Subject: Entrance Treatments

- Applicable Standards:**
2. Retention of Historic Character
 5. Preservation of Distinctive Features, Finishes and Craftsmanship
 6. Repair/Replacement of Deteriorated or Missing Features Based on Evidence

Tavern after rehabilitation before appropriate entrance installed.

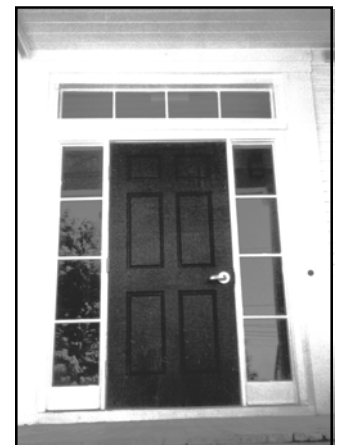
Application 1 (*Incompatible treatments later modified to meet the Standards*): This large three-story, frame building was in continued use as a tavern since 1820 and has now been rehabilitated as an assisted living residence. The interior of the building had undergone a great amount of alteration over the years, but the primary elevation retained its historic form and front entrances with transoms and sidelights. Ornamental steel doors with inappropriate leaded glass panels, sidelights and transom were installed. In order to bring the project into conformance with the Standards, remedial work involved replacing the doors with wood six-panel doors and reproducing the historic configuration of the sidelights and transom based on photographic documentation.

Inappropriate entrance design.

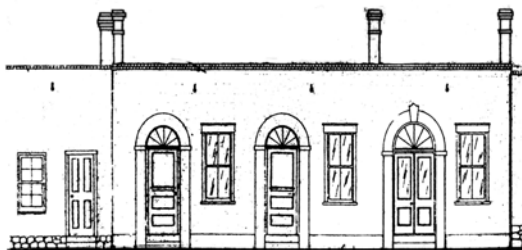
Application 2 (*Incompatible treatment*): This two-story brick commercial building, dating from the 1890s, is being rehabilitated for use as law offices. The first floor level was covered with stucco sometime in the past and a compatible storefront, except for the entrance bay, was constructed during a previous rehabilitation. The proposed treatment for the entrance included double doors flanked by multi-paned sidelights, surmounted by a solid stucco panel covered by an awning. The sidelights are residential in design and not compatible with the commercial character of this building. In order to bring the project into conformance with the Standards, the sidelights will be removed and wider double doors installed to fill the central bay. The stucco panel above the doors will be replaced with a glass transom to match those in the adjacent bays, and the awning, which had been proposed only to conceal the stucco panel, will be eliminated.
